CERTAIN 2016 MODEL YEAR TRANSIT CONNECT VEHICLES — FUEL FILLER PIPE LABEL CORRECTION

FIGURE 1

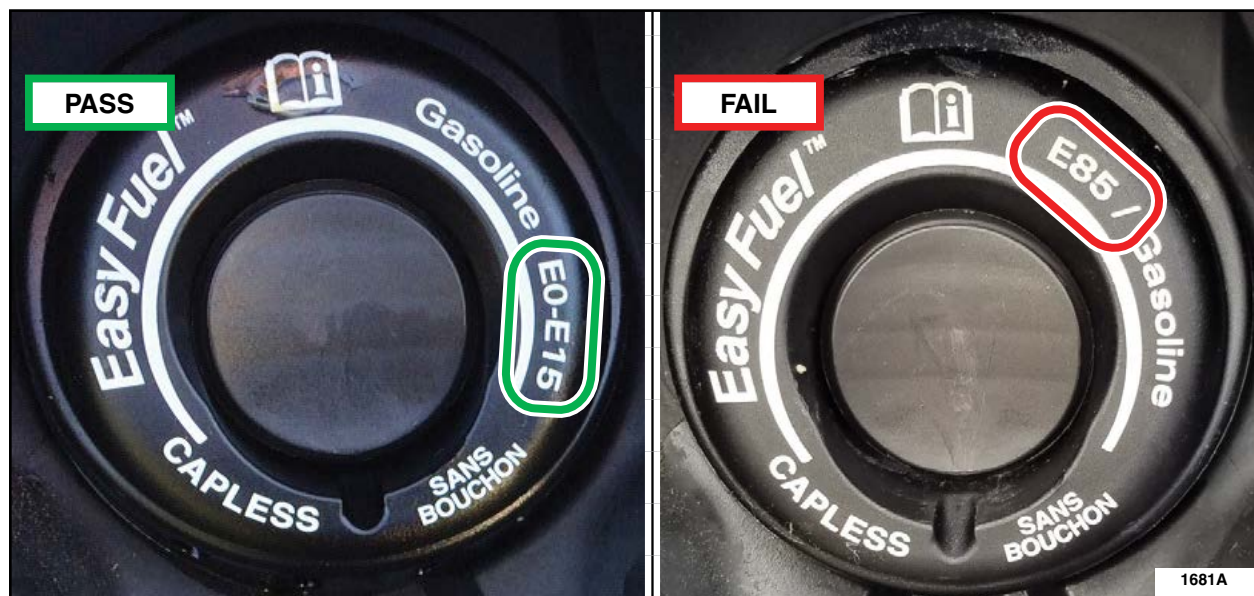
In some of the affected vehicles, the fuel filler pipe identification ring was incorrectly labeled for E85 fuel usage. The use of E85 fuel may result in drivability issues, illuminated Malfunction Indicator Light, and the vehicle may not pass emission or smog tests that may be required in your area.

1. Inspect the vehicle's fuel filler pipe identification ring for the presence of the "E0-E15" or "E85 /" marking.
 - If the "E0-E15" marking is present, no further action is required.
 - If the "E85 /" marking is present, proceed to Step 2.

2. Remove the "E85 /" marking using acetone. See Figure 2.

- a. Mask the area/markings surrounding the "E85 /" marking.
- b. Using acetone applied to an abrasive pad, remove the "E85 /" marking from the fuel filler pipe identification ring. Repeat as required to remove all of the "E85 /".
